TS:22:03009
UFC:5822.00

Subject: REVISION 25 OF THE TRUPACT-II SHIPPING PACKAGE APPLICATION,
DOCKET NO. 71-9218, AND REVISION 8 OF THE HalfPACT SHIPPING
PACKAGE APPLICATION, DOCKET NO. 71-9279
(EPIDS L-2021-LLA-0033 AND L-2021-LLA-0034)

The responses to the questions submitted in Reference 6 are provided in Attachment A (Reference 7). New changes to the documents are summarized in Attachment B and are indicated by right-bars in the margin of the documents (“|”). Right-bars in the margin of the documents (“|”) indicating technical changes made to the documents in the original submittal and the subsequent amendments of this application (References 2, 4, and 5) have also been retained with this submittal.

Figure 1 – SC-30G2 Gamma Scan Test Assembly Exploded View

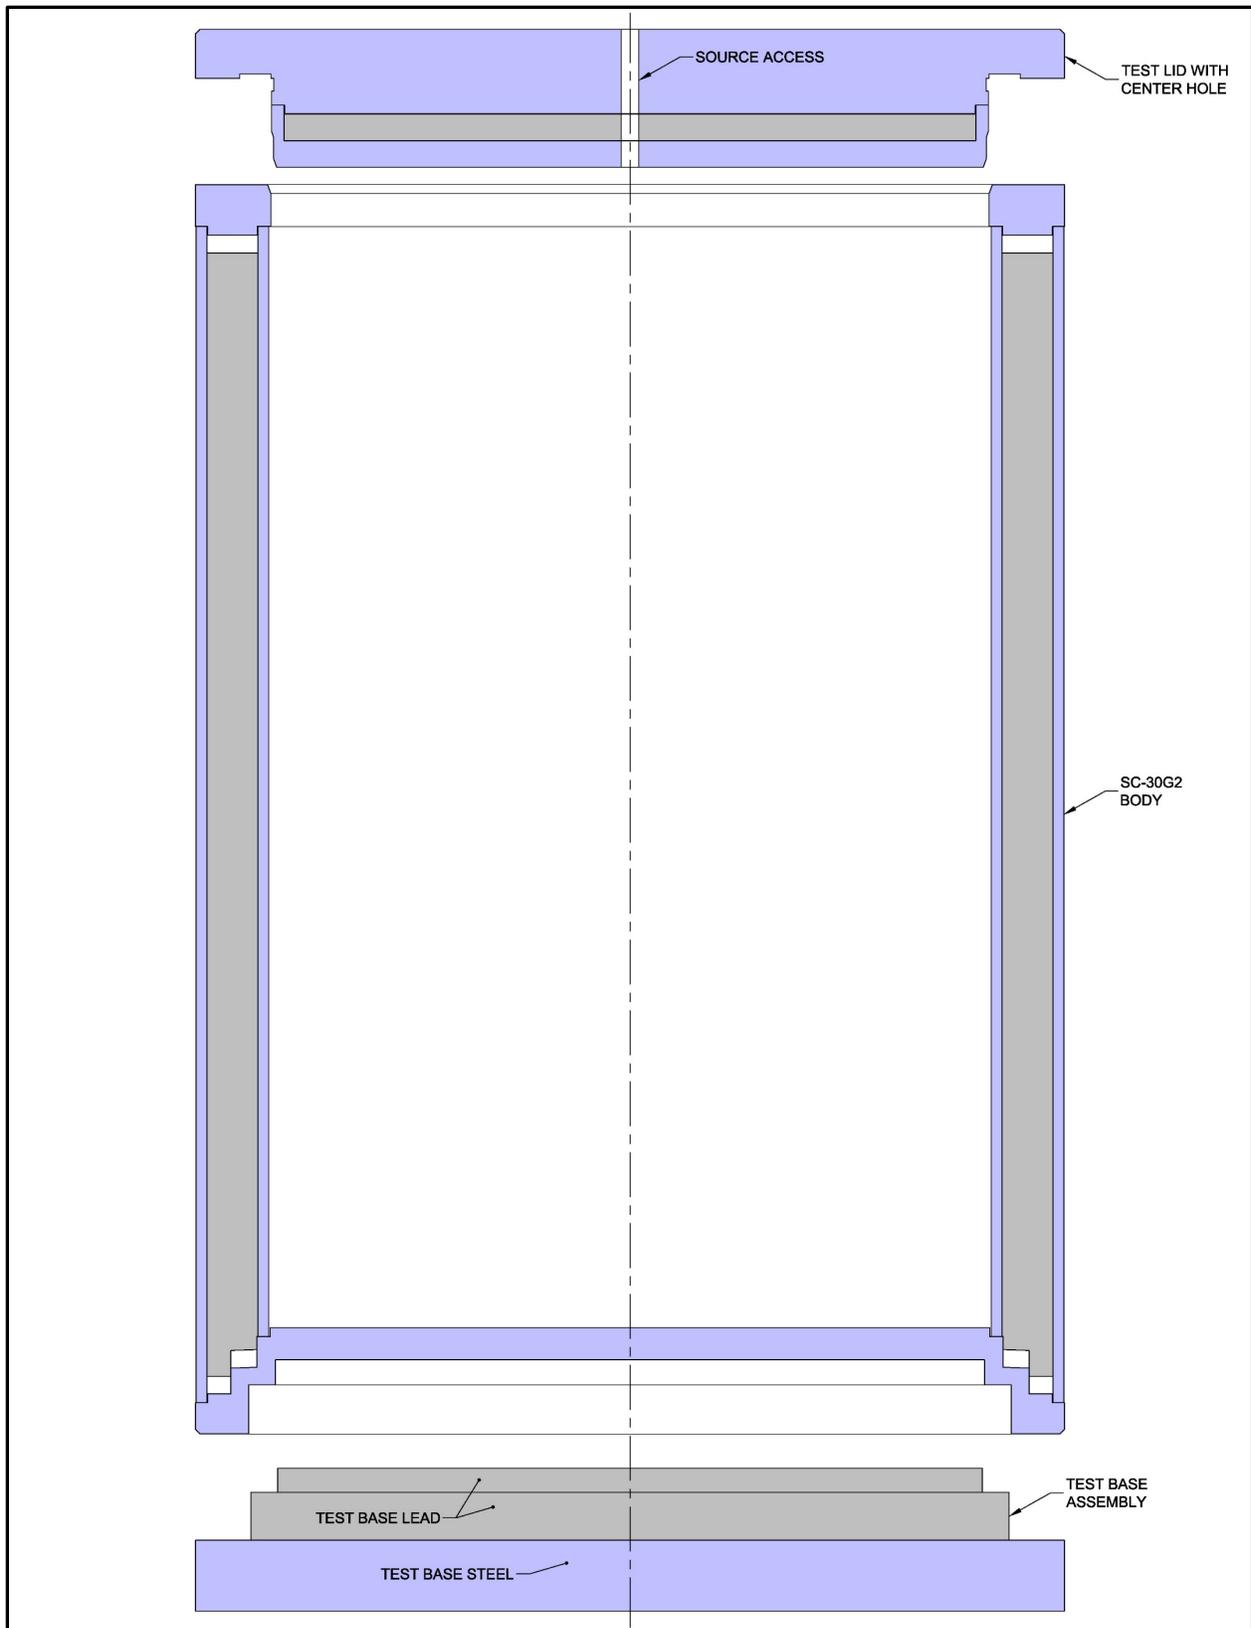
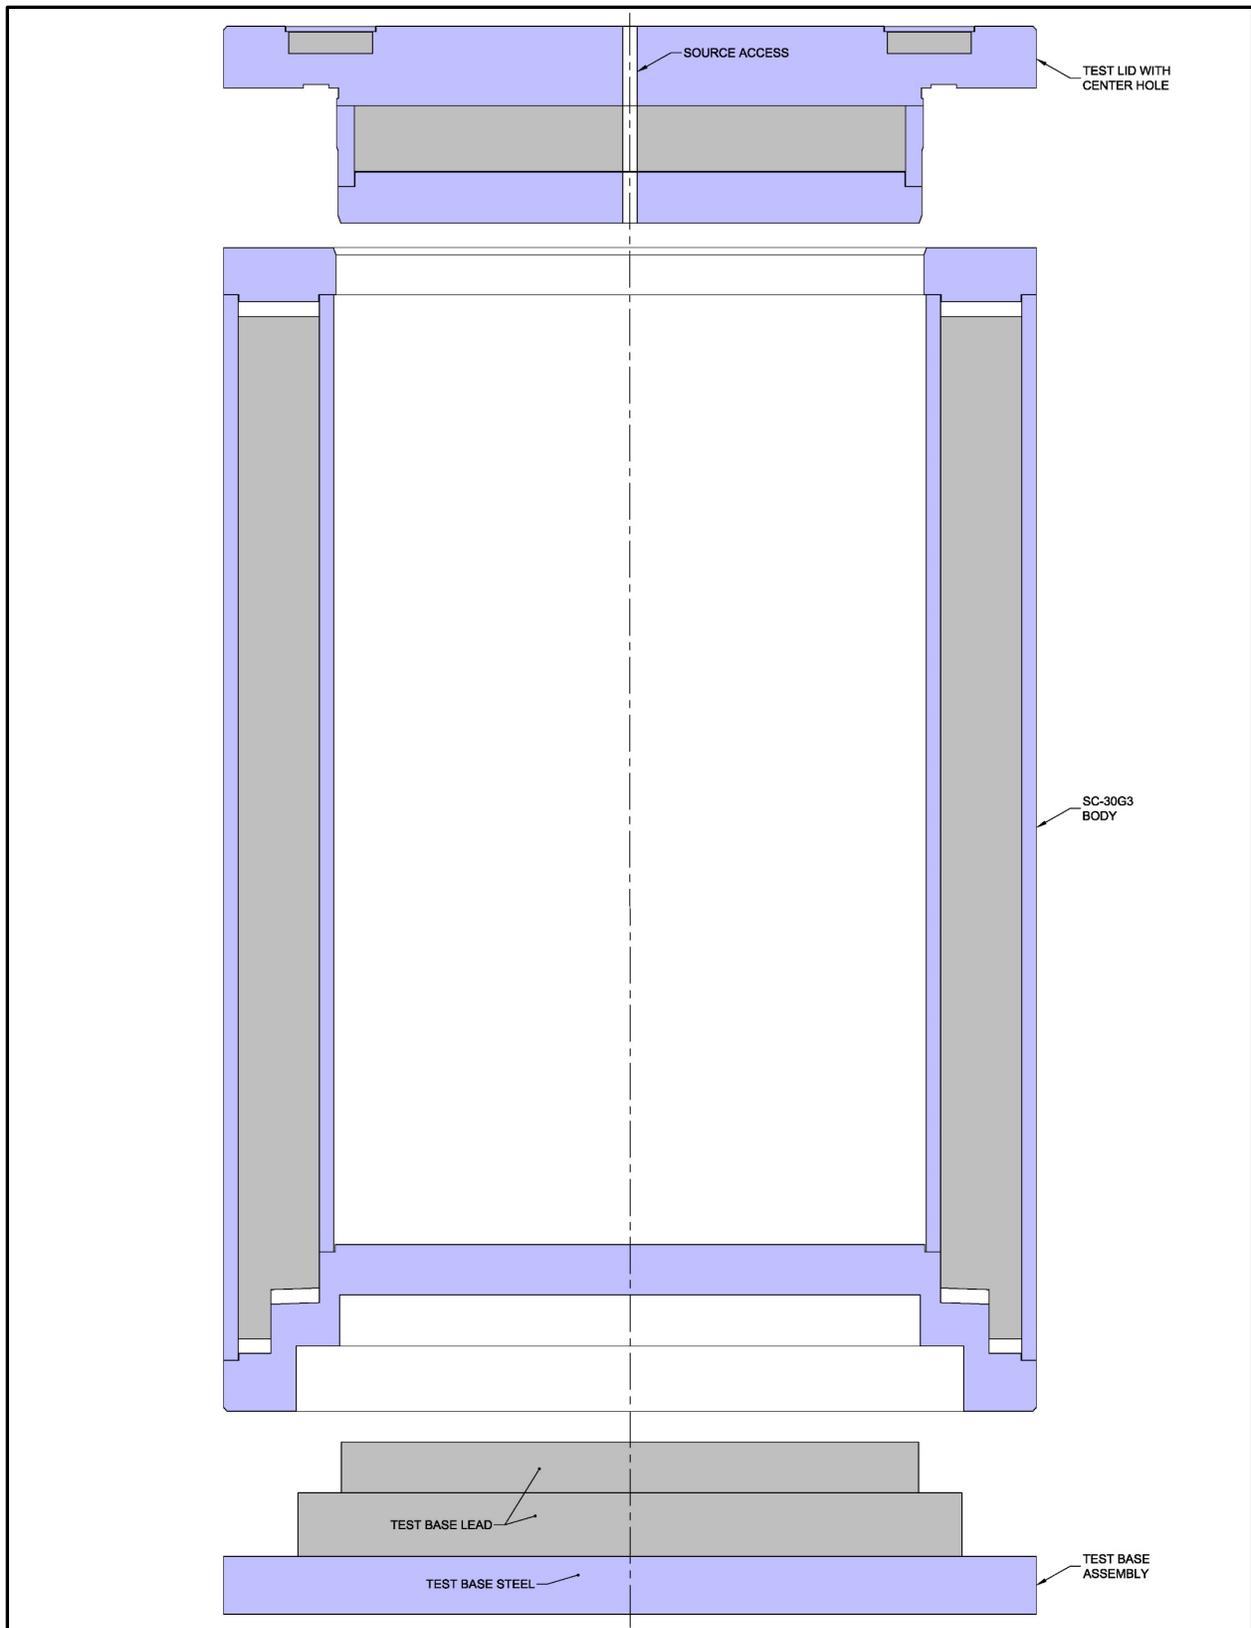
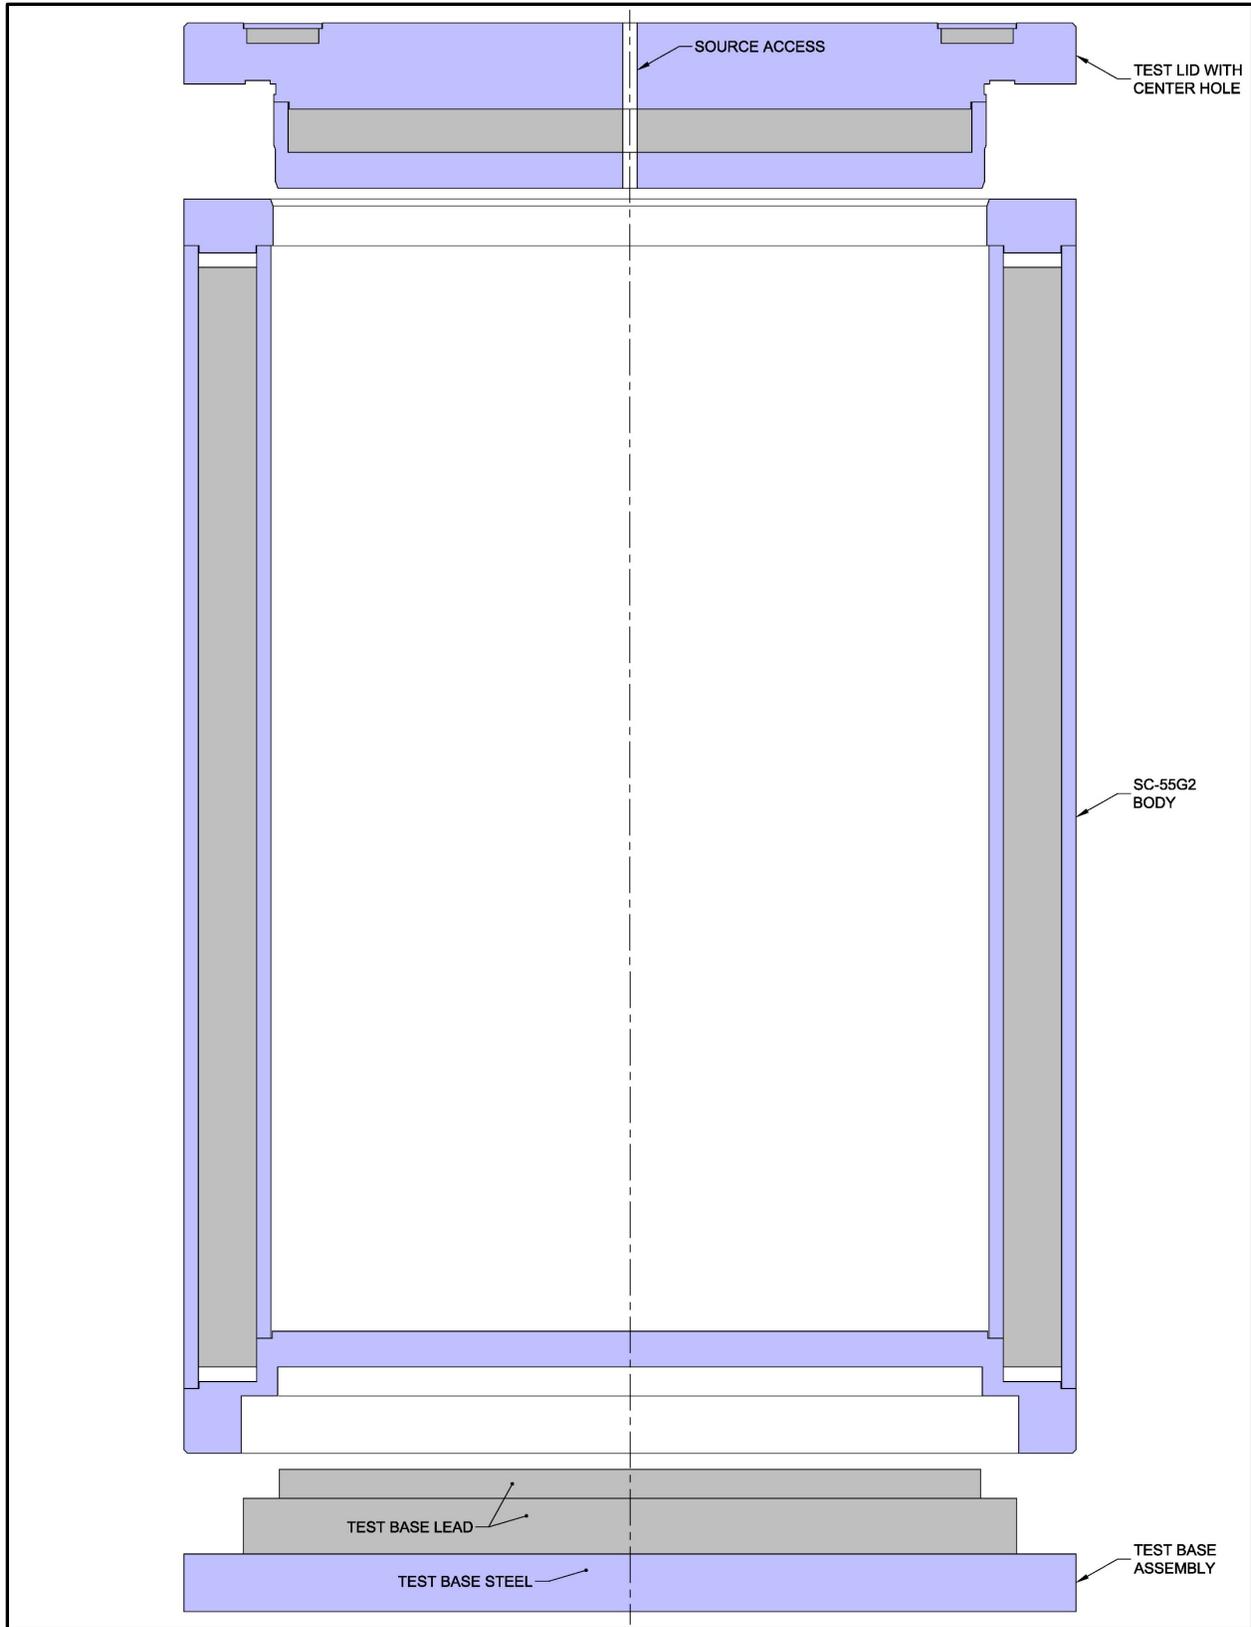
3. Is the gamma scan performed on an assembled container or only on individual components?

With reference to Figure 1, Figure 2, and Figure 3 for the SC-30G2, SC-30G3, and SC-55G2 shielded containers, respectively, the gamma scan process is performed on the container body without the base lead or outer base plates installed, and without the prototypic lid installed.

To simulate the presence of these components for ALARA purposes, a test base is used that has lead and steel plates of similar thicknesses and diameters as specified in the fabrication drawings, less sufficient sliding clearances to fit within the container body base for gamma scan testing. Similarly, the test lid is a prototypic lid, but also includes a center hole to allow access for the gamma scan test's radioactive source and a slightly reduced step diameter for sufficient clearance with the unfinished upper flange.

Upon successful completion of gamma scan testing, the base lead and steel plates are machined and installed in the body assembly and the filter shield plug and lid lead plate is machined and installed in the lid assembly.
